BENCOR 2ND ADDITION
WICHITA, SEDGWICK COUNTY, KANSAS

RE: SUB 2000-10 -- Final Plat of BENCOR SECOND ADDITION

CASE NUMBER: SUB 2000-10 -- BENCOR 2ND ADDITION

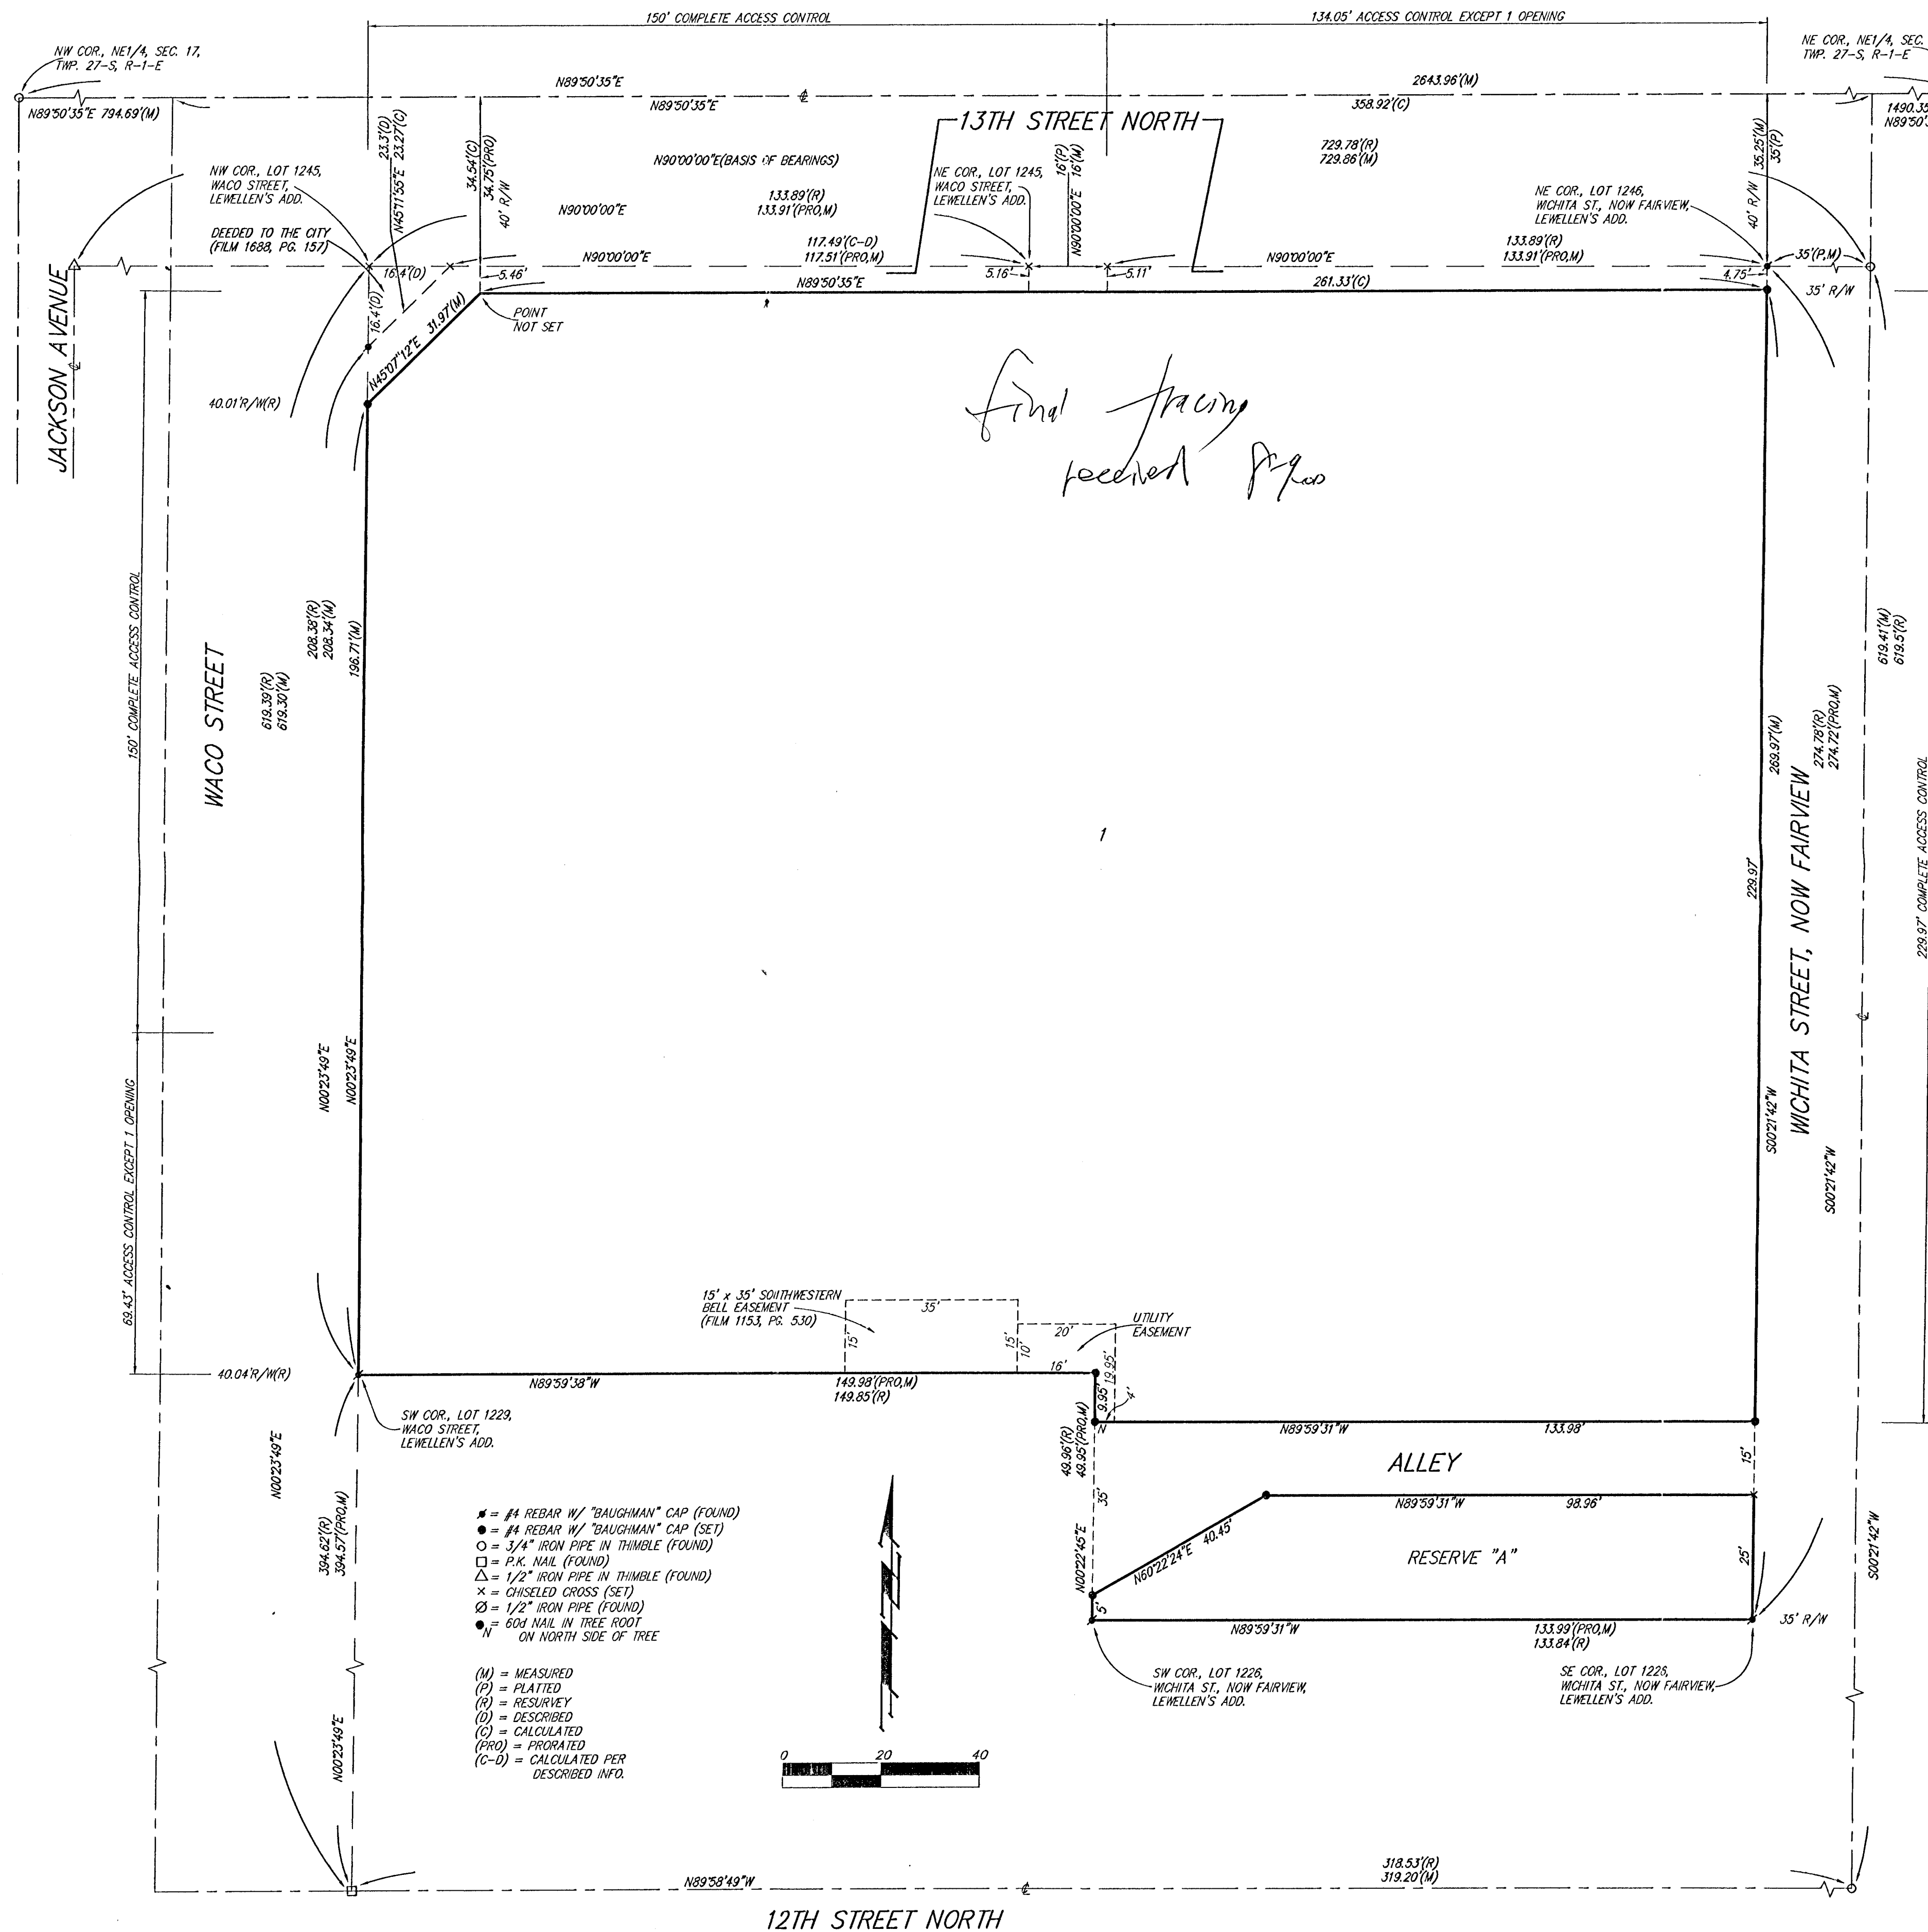
- A. Municipal services are available to serve the site. **City Engineering** needs to comment on the need for any easements or guarantees. *A guarantee shall be submitted for abandonment of the existing sewer line. A temporary easement should be established to cover the sewer line until abandonment.*

- C. **City Engineering** needs to comment on the status of the applicant's drainage plan. *The drainage plan is approved.*
- D. The plat proposes one access opening along both Waco and 13th St. North. In accordance with the approved site plan, no access openings are proposed along Fairview, and complete access control should be dedicated along Fairview. Distances should be shown for all segments of access control. The dedication of access controls shall be referenced in the plat's text. In accordance with the Subdivision regulations, any access openings located within 250 feet of the intersection of 13th St. North and Waco are limited to right-turns only, and shall be referenced on the face of the plat; or a guarantee provided for the future construction of a raised medial.

- F. **Traffic Engineering** needs to comment on the need for additional right-of-way for 13th St. North or Waco. A 50-ft half-street right-of-way is typically required for arterials. *Traffic Engineering has approved a 40-ft half-street right-of-way.*

- I. A "Notice of Protective Overlay" document indicating the Protective Overlay has been filed with the MAPD shall be submitted.
- J. The legal description shall be revised to reference Lot 1226 of the Lewellen's Addition and include a metes and bounds description of Reserve A.

- K. The plat's text shall include language that a drainage plan has been developed for the plat and that all drainage easements, rights-of-way, or reserves shall remain at established grades or as modified with the approval of the applicable City or County Engineer, and unobstructed to allow for the conveyance of stormwater.

- R. Recording of the plat within thirty (30) days after approval by the City Council and/or County Commission.
- S. The representatives from the utility companies should be prepared to comment on the need for any additional utility easements to be platted on this property. Southwestern Bell requests that the vacated alley be retained as a utility easement. Any relocation or reconstruction of utilities made necessary by this plat shall be the responsibility of the Applicant.
- T. The applicant is reminded that a disk shall be submitted with the final plat tracing to the Planning Department detailing this plat in digital format in AutoCAD. This will be used by the City and County GIS Department.
- U. The applicant shall guarantee the paving of the proposed alley.
